TR-140455

Proposed Quiet Zone: SE Chelsea Dr. (Crossing ID 090074M)
Public Authority Application to the FRA Under 49 CFR 222.39(b)

Attachment 3

Chelsea Dr. Quiet Zone

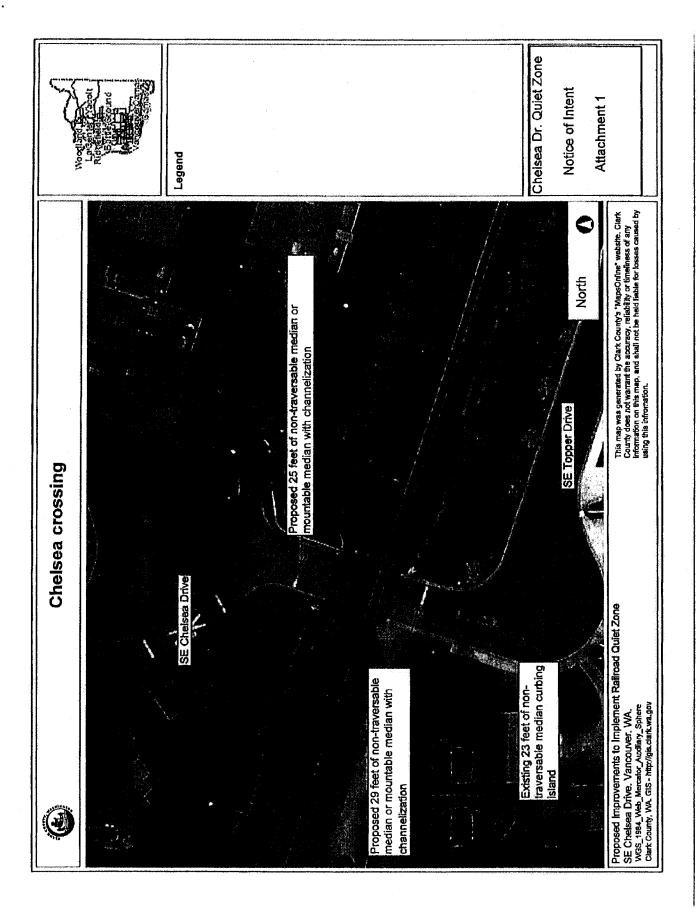
- 1) The regulatory section under which the Quiet Zone would qualify;
- 2) Whether the City is seeking risk reduction credit and which specific type of safety measure is being used (Alternative or Supplemental). The aerial included in the Notice references a 23' existing non-traversable median with a proposed additional 29' of non-traversable median on the south side of the tracks, as well as a 25' proposed non-traversable median on the north side of the tracks:

Proposed 25 feet of mountable median with channelization

Proposed 29 feet of mountable
